From: [REDACTED]
Sent: 02 January 2025 12:43
To: Andy Watt
Cc: [REDACTED]
Subject: DM/24/2957: The Prince Albert, Copthorne Bank, Copthorne, Crawley

I am writing on behalf of Mr. and Mrs. Wood of Balmoral, Brookhill Road, Copthorne, to express their concerns regarding the above planning application which includes a proposed apartment building opposite their property.

5. Visibility Splays and Road Safety

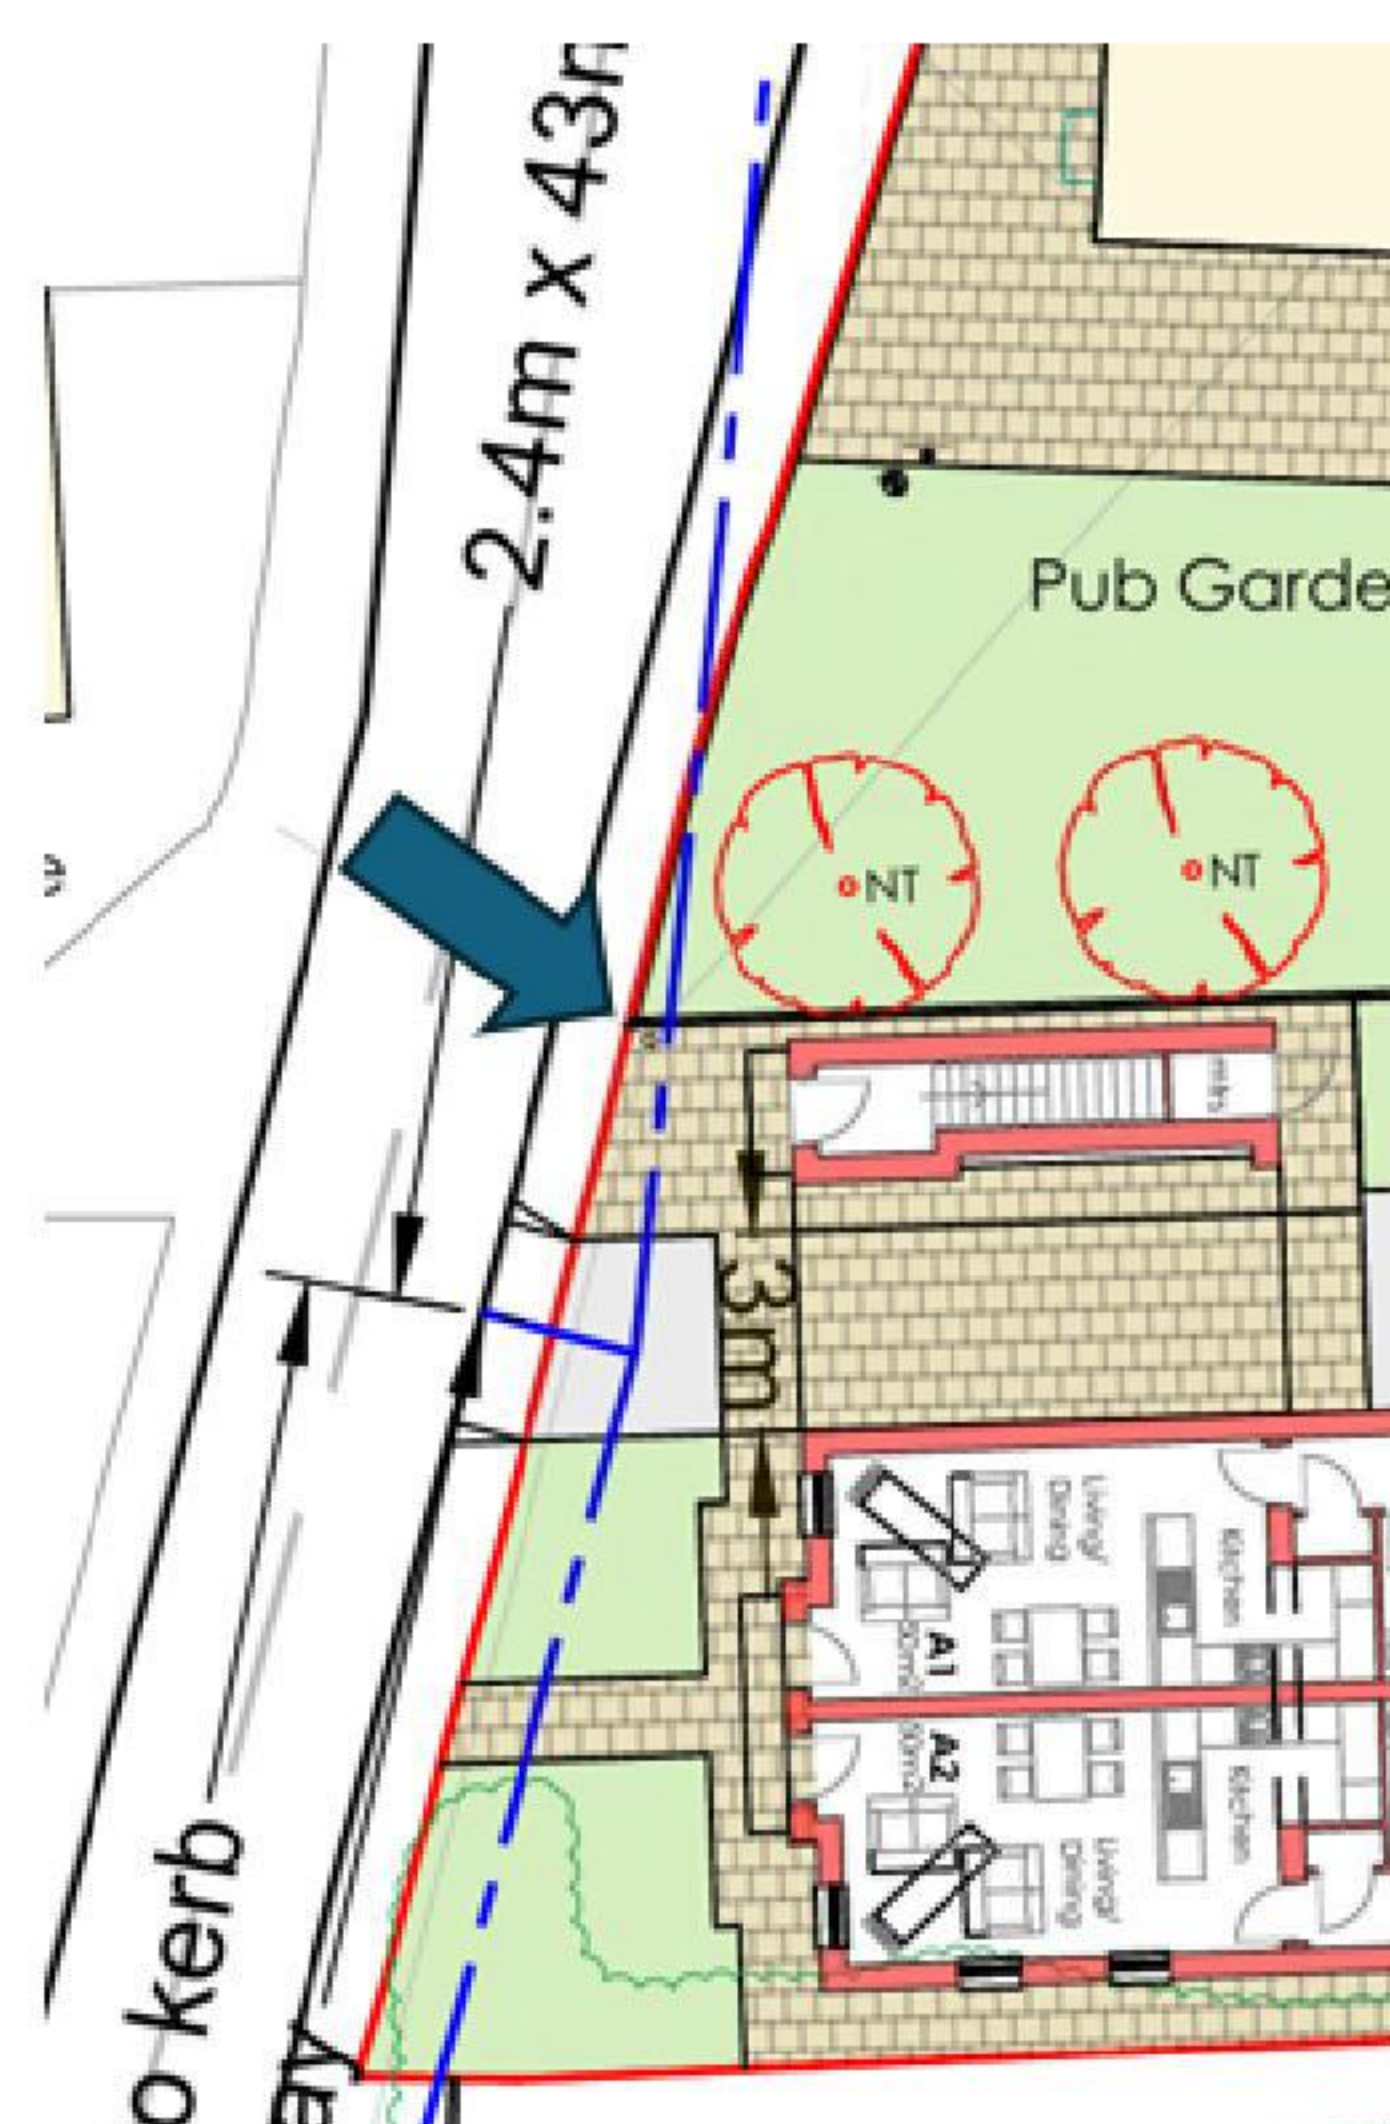
- 1. Compliance with MSDC Design Guide (DG41)**
The proposed building does not comply with the guidance provided in Principle DG41 of the MSDC Design Guide for development on sloping sites. The design does not adequately respond to the falling gradient of Brookhill Road, the lower road level in Dawn Rise, or the height of the adjacent cottages and chalets to the south. Additionally, as set out above, the design does not facilitate level or step-free access to the ground-floor entrances.

- 2. Ridge Height Comparison**
It is possible that the ridge height of the proposed building may exceed that of the Prince Albert pub itself. Assuming the existing pub has a depth of approximately 6.00 meters and a roof pitch of 45 degrees, the overall ridge height would be approximately 9.00 meters, which is lower than the proposed building's ridge height of 9.25 meters. It would be quite inappropriate for the proposed building not to be subservient in height to the Prince Albert which is a landmark building on a prominent junction.

- 3. Flank Elevation and Visual Impact**
The size of the flank elevation as viewed from the south would appear visually overbearing, especially given that the building is 2.5 storeys high, which is out of context with the surrounding street scene of bungalows, chalets, and two-storey houses. While an attempt has been made to conceal the crown-topped roof with a weak half-hip detail, this is not in line with the MSDC Design Guide's recommendations for roof design.

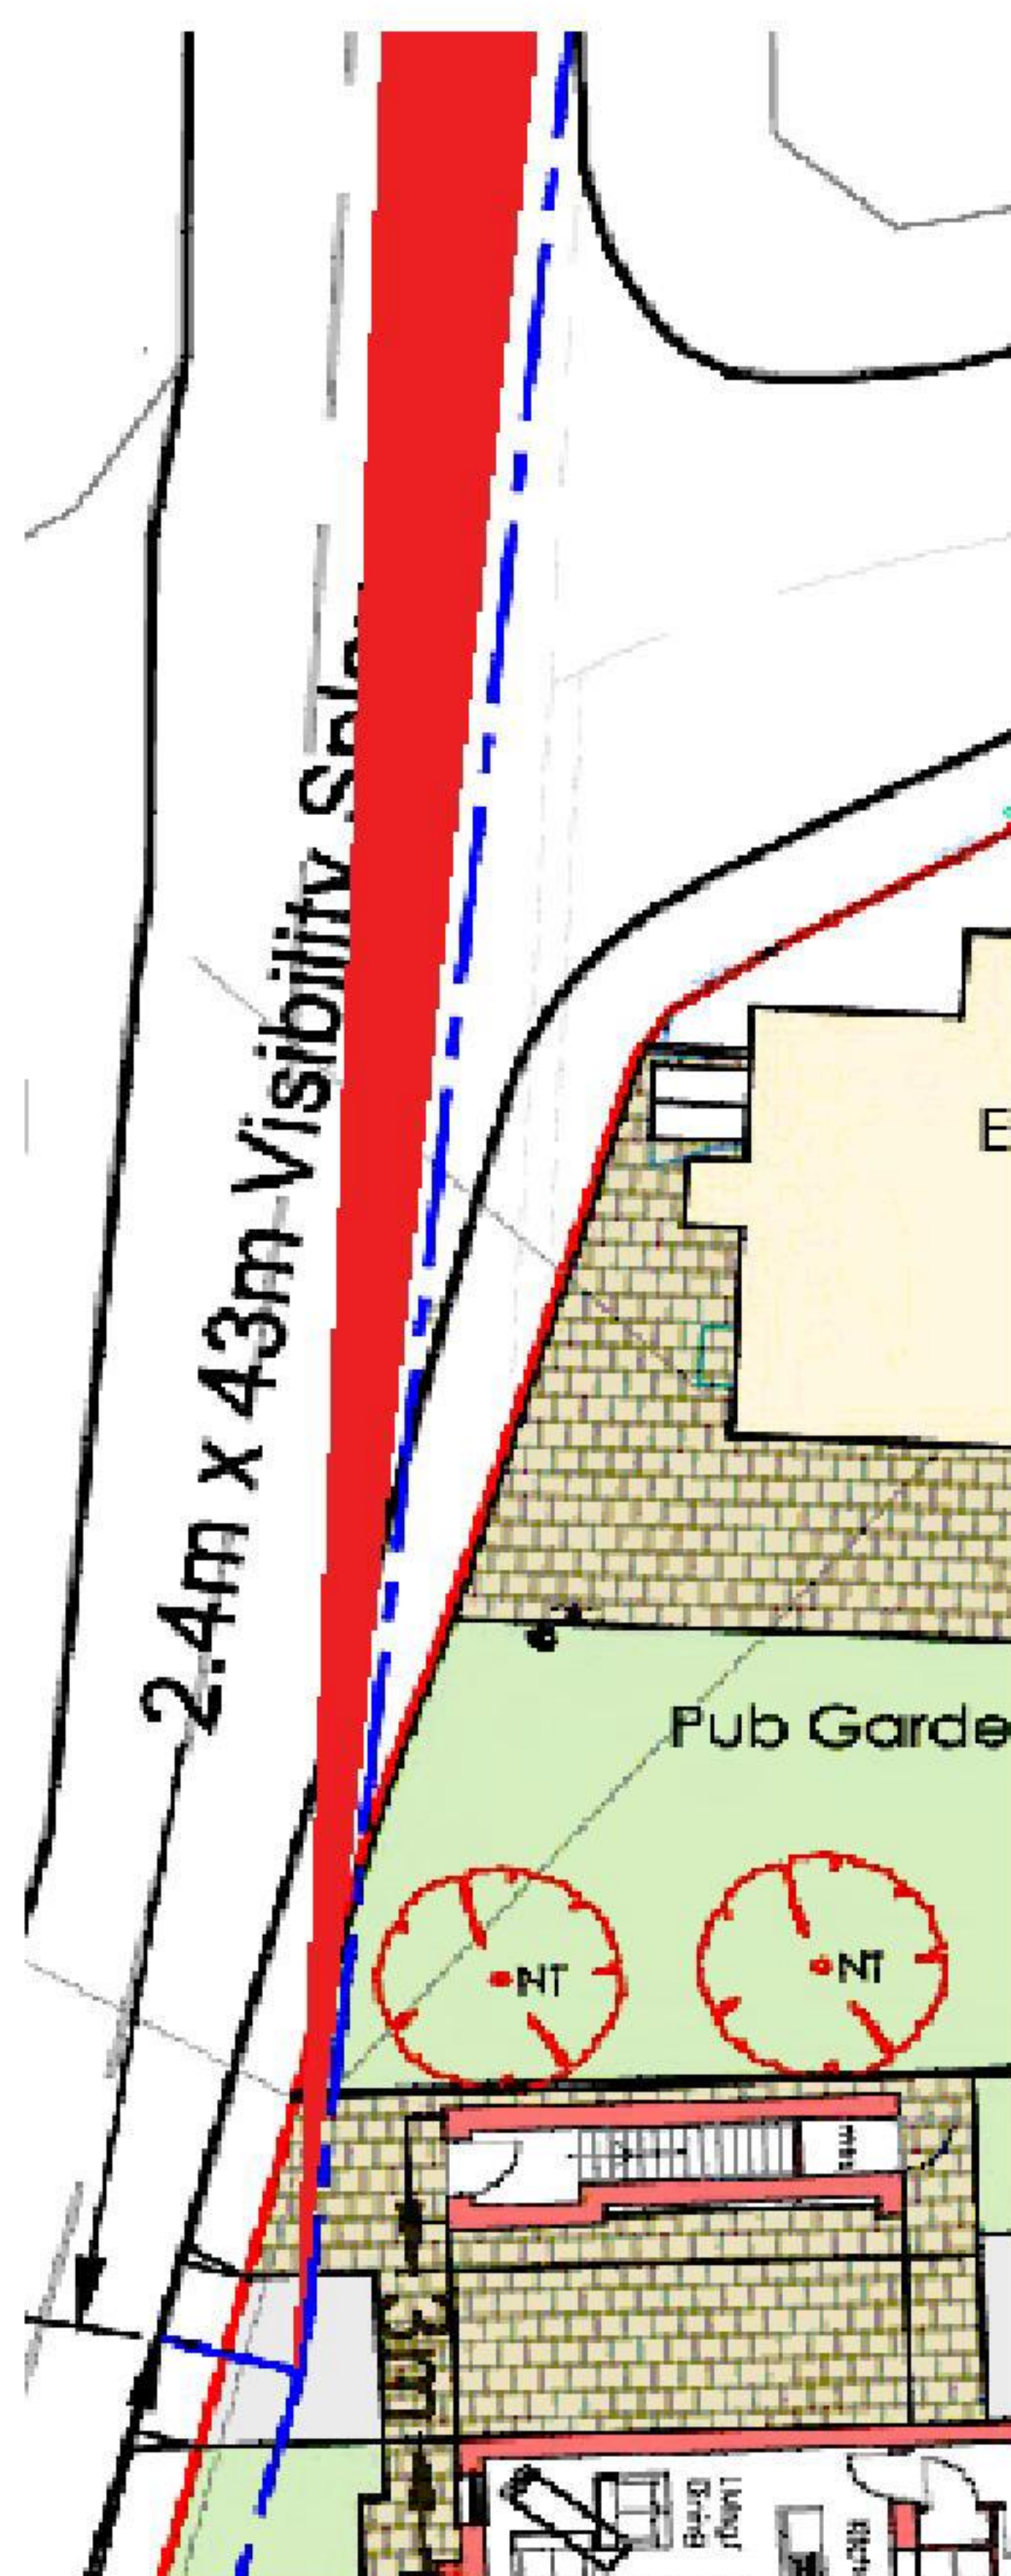
Section 4.2.3 of the Transport Report states, "Visibility splays from the residential access are shown within Appendix 3.2a. This plan shows that visibility splays of 2.4m x 43m are achievable to oncoming cars." However, the visibility splay plan appears to show an overhead electricity pole (marked as a small black circle):

The visibility splay is significantly compromised as shown below:

There is a risk to vehicles, but particularly to cyclists and motorcyclists, who may well be tracking closer to the kerb line.
